Historic Architectural Review Commission
Staff Report for Item 9

Application Number: H17-03-0011

Address: #1000 Southard Street

New accessory structure and new rear IPE deck.

**ACC.
 STRUCTURE**

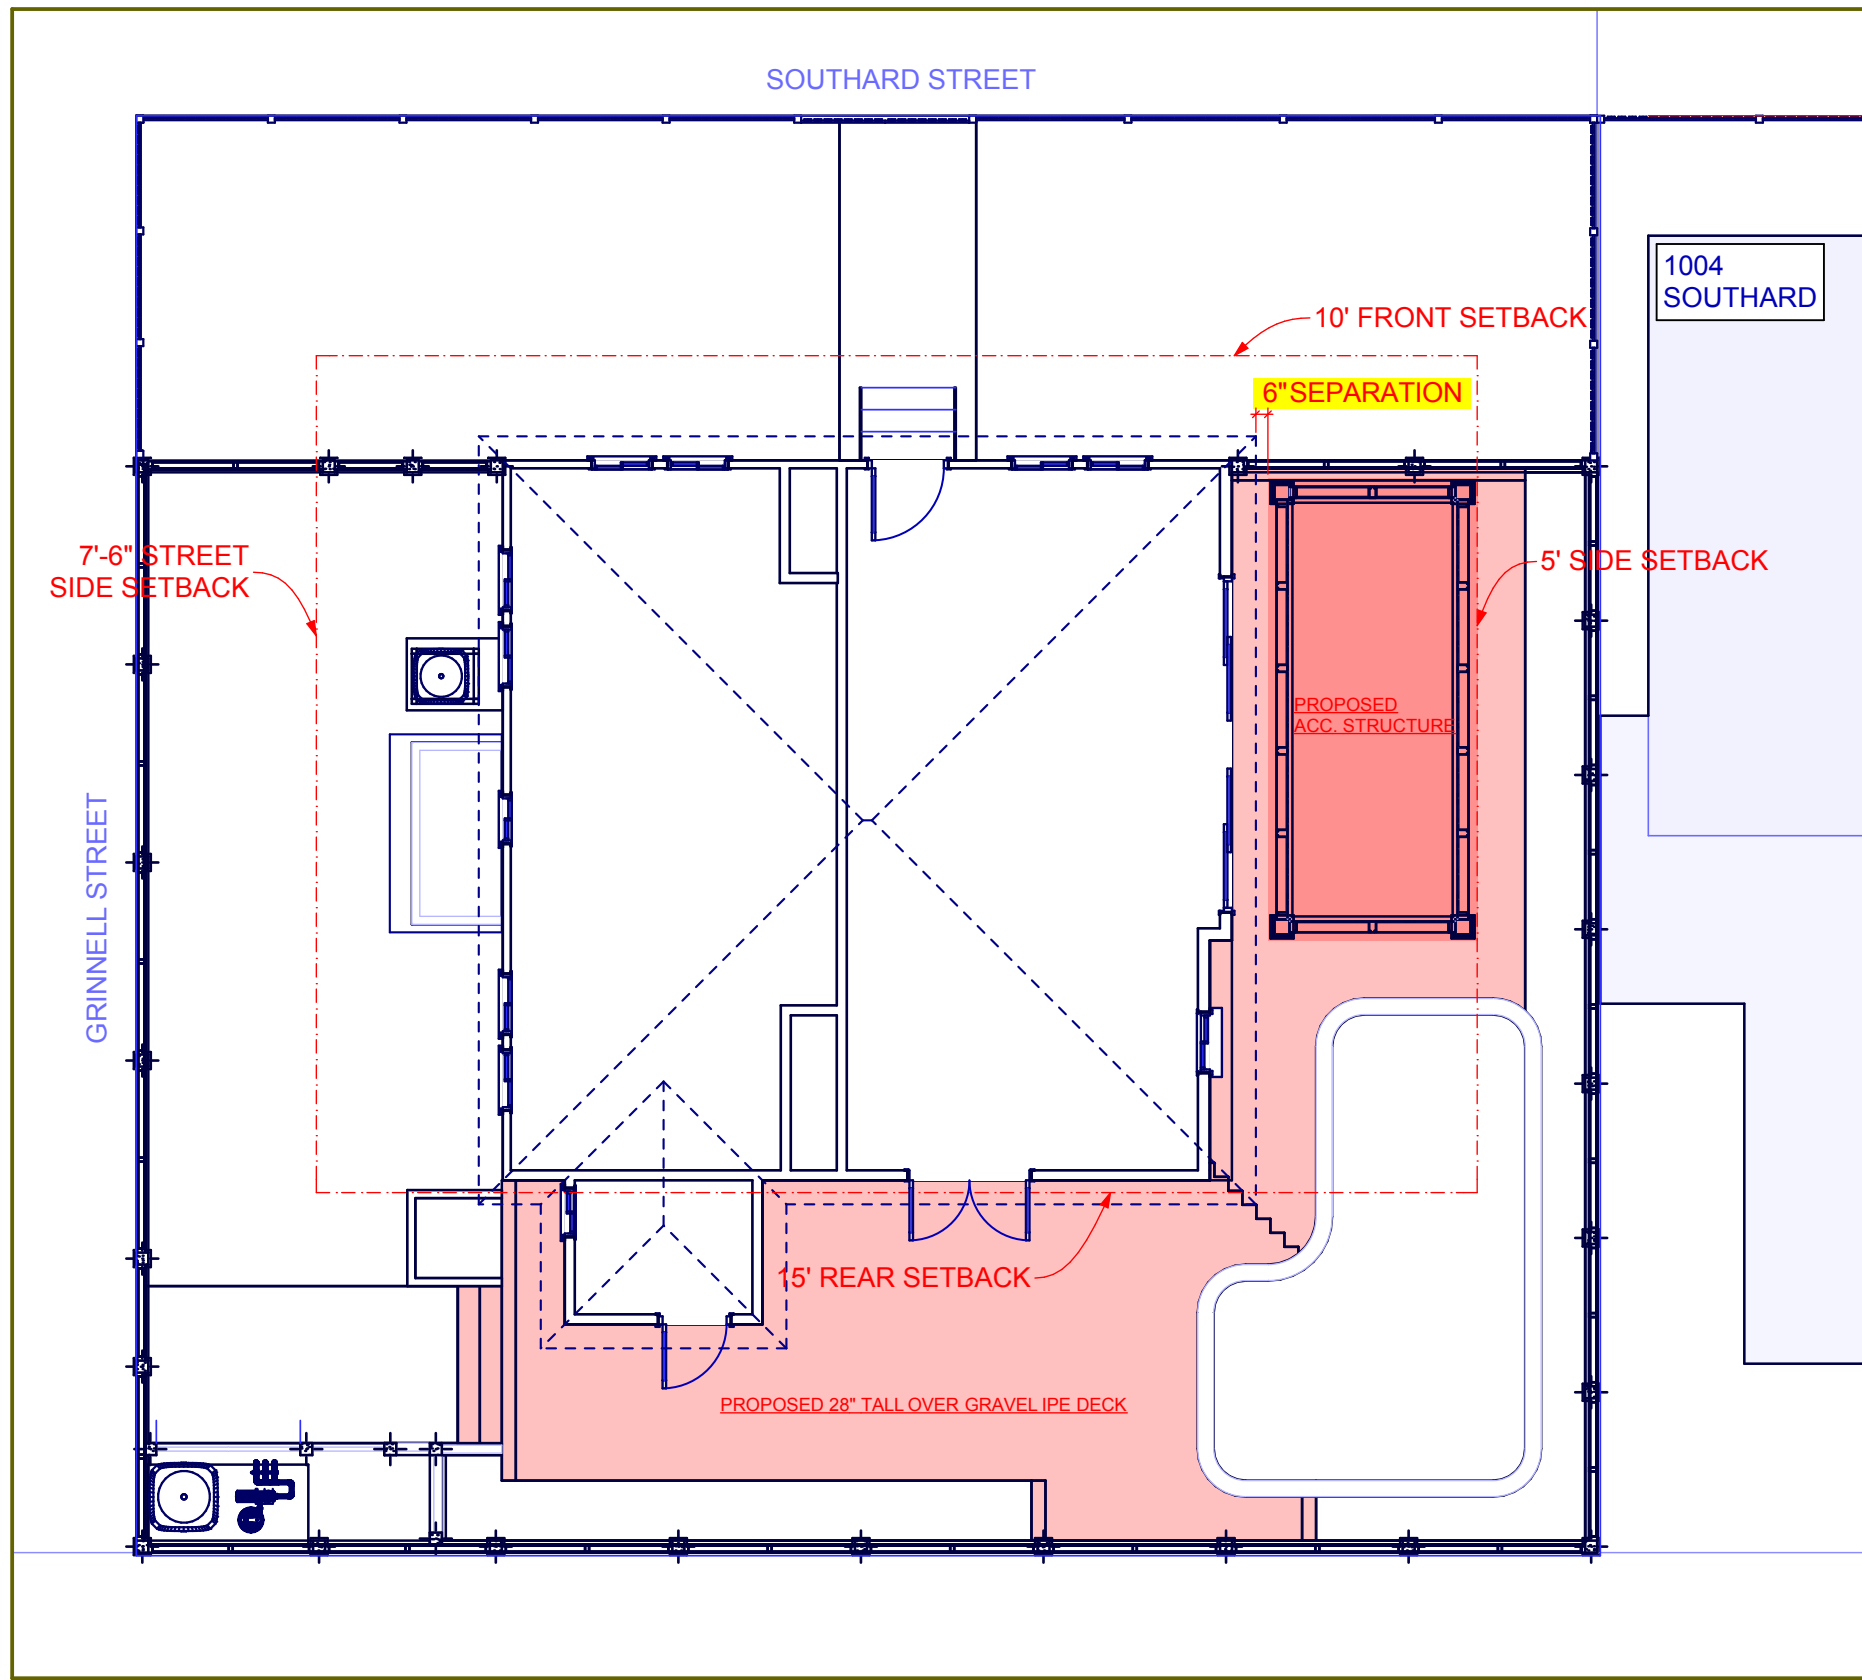
The Certificate of Appropriateness in review is for the construction of a porch structure that will be located at the east side of the main house. The structure will be detached from the house approximately 6 inches and will be made of wood and will have louvers on its upper portion and under the roof. Although the proposed structure will be lower than the main house, it will be higher than the eave line of the house. The structure will be visible from Southard Street. One of the character defining features of the main house is its high-pitched hip roof and the predominant eave lines with the exposed rafter's tails. The proportions of the proposed structure in contrast with the main house are out of balance as the structure is higher than the exterior walls of the house. The structure will be built over an existing deck that is approximately 28 inches tall and will extend approximately up to 13'-3 3/4" on its highest point.

It is staff's opinion that the proposed structure is inconsistent with the cited SOIS and guidelines and HARC guidelines. The proposed scale and proportions as well as the location of the structure are inappropriate, as it will be located close to the main façade of the house and visible from the street. By walking the street, you can find no accessory structures located immediately next to a main house nor visible from the street.

DECK

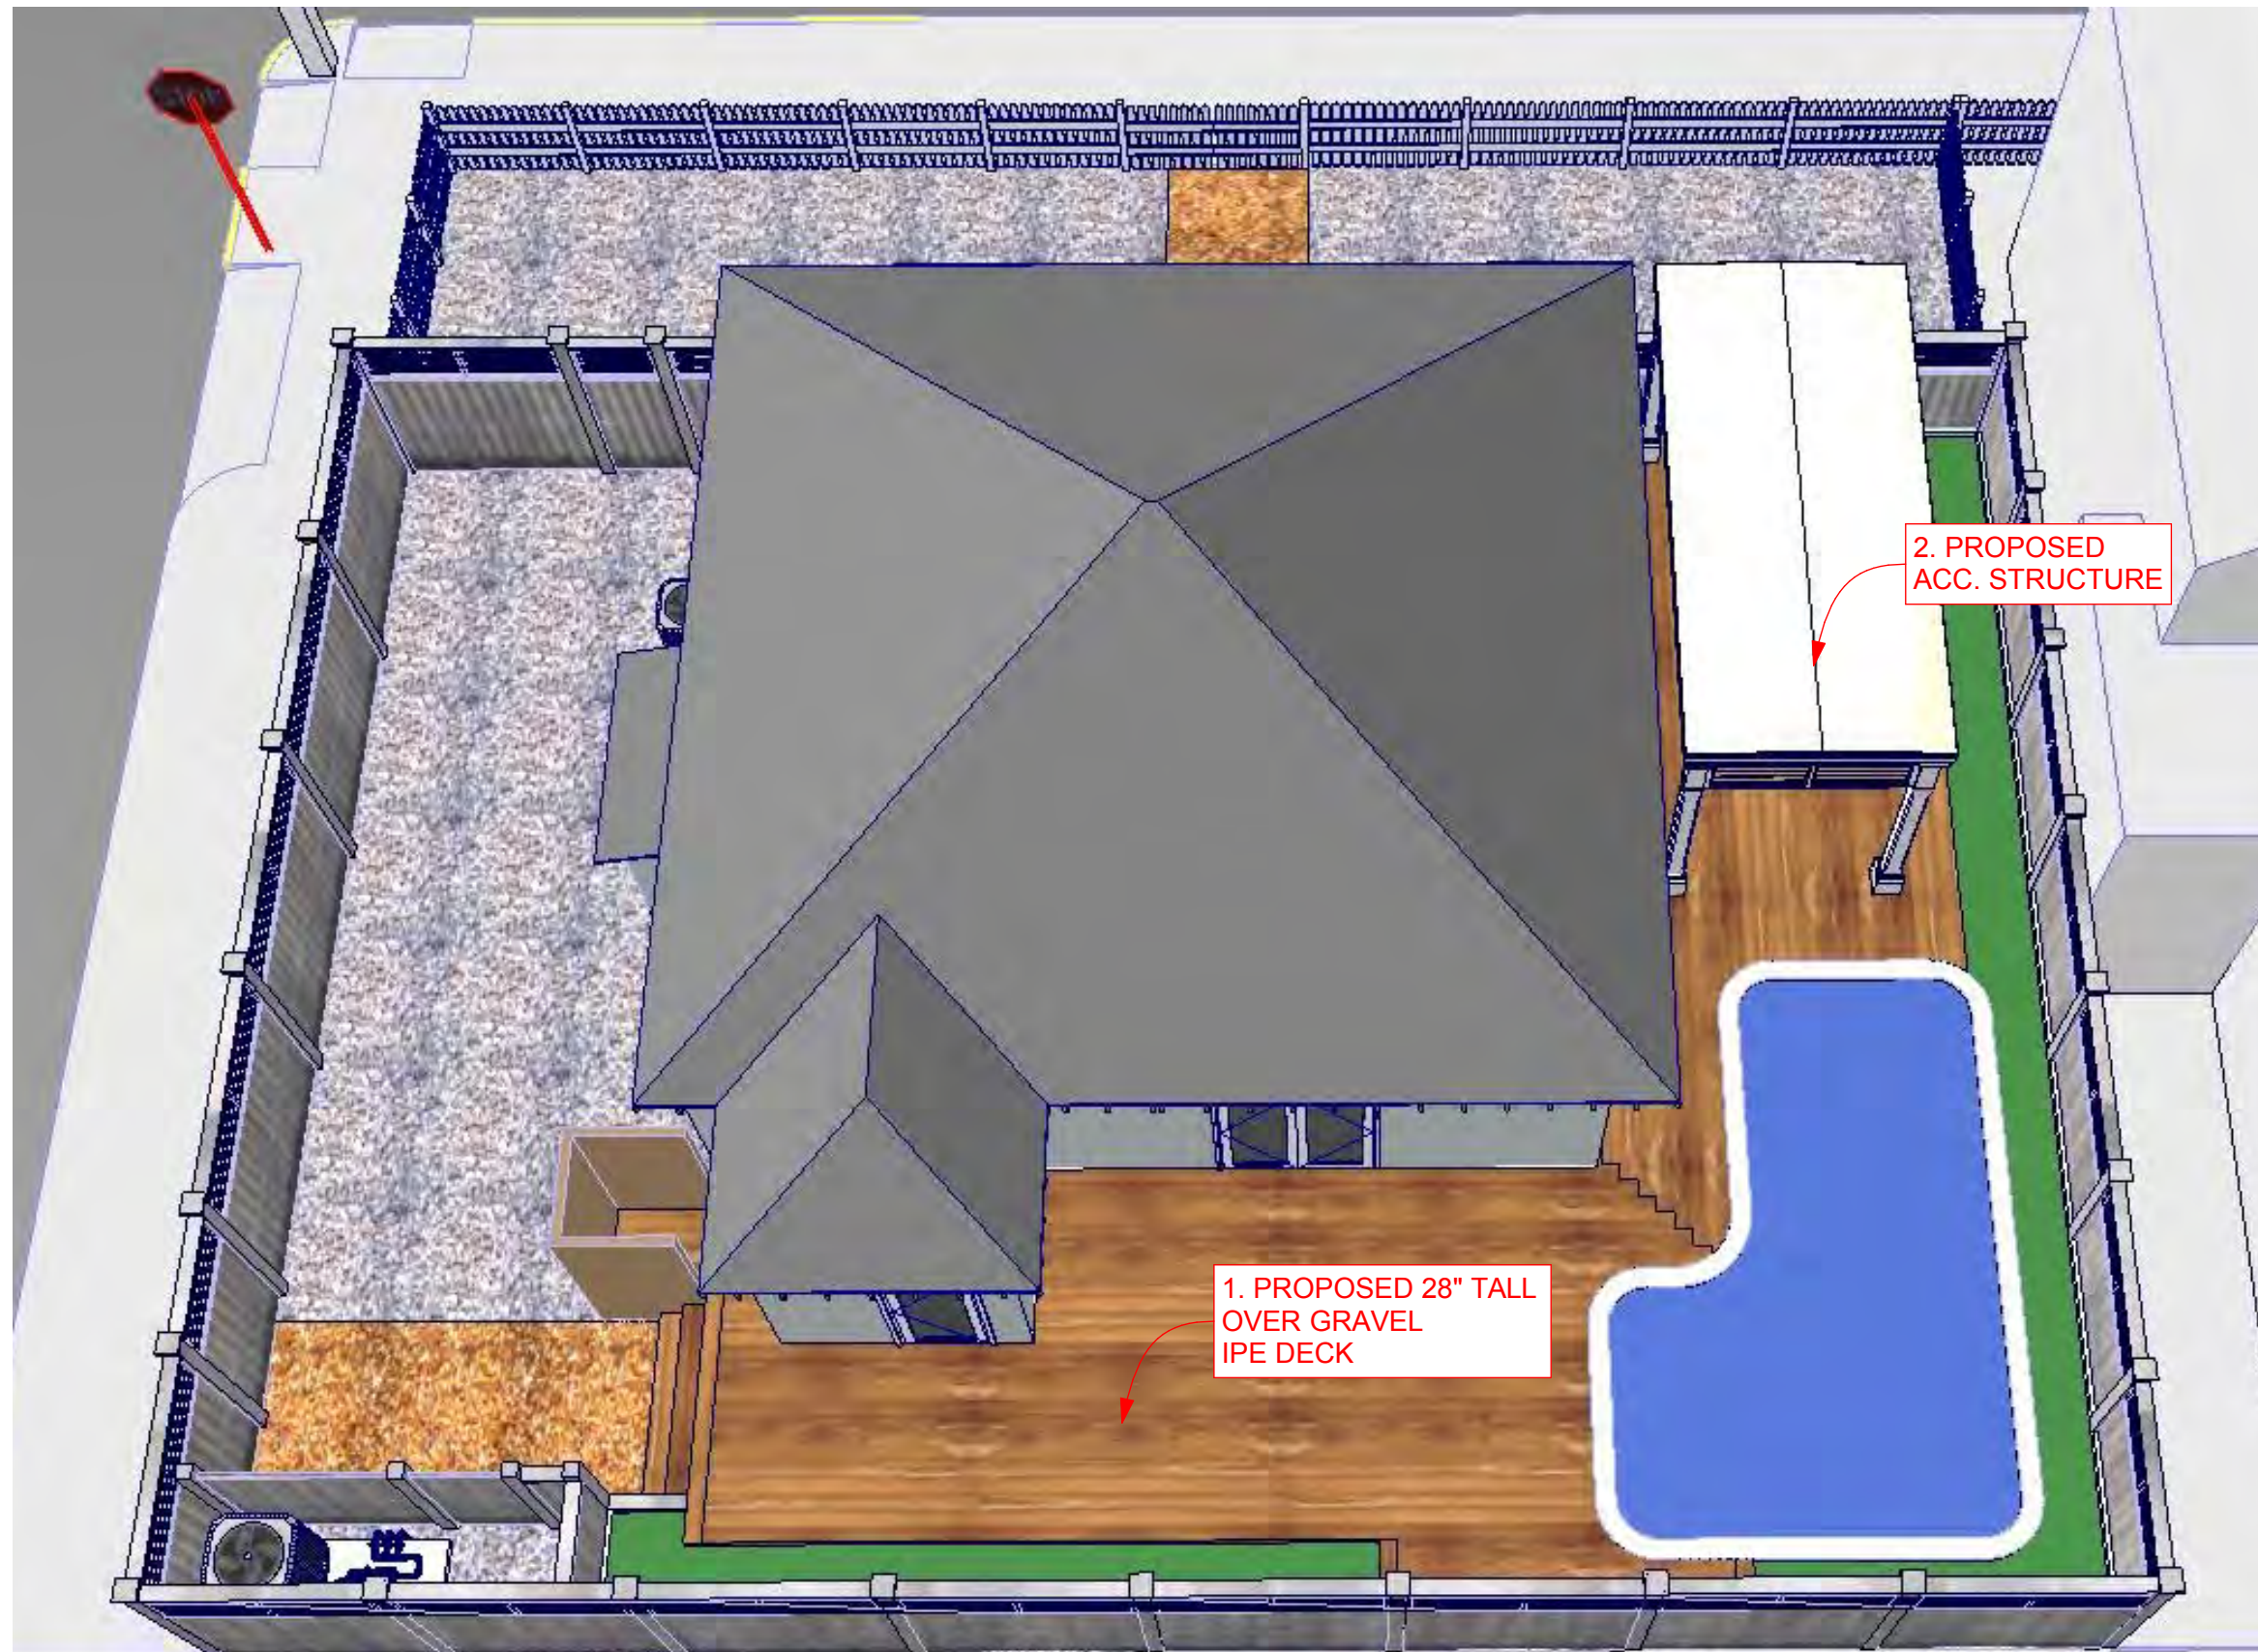
The proposed design also includes the removal of existing pool decking material and installation of IPE decking boards.

Staff finds the request to replace the existing pool decking boards with IPE appropriate.
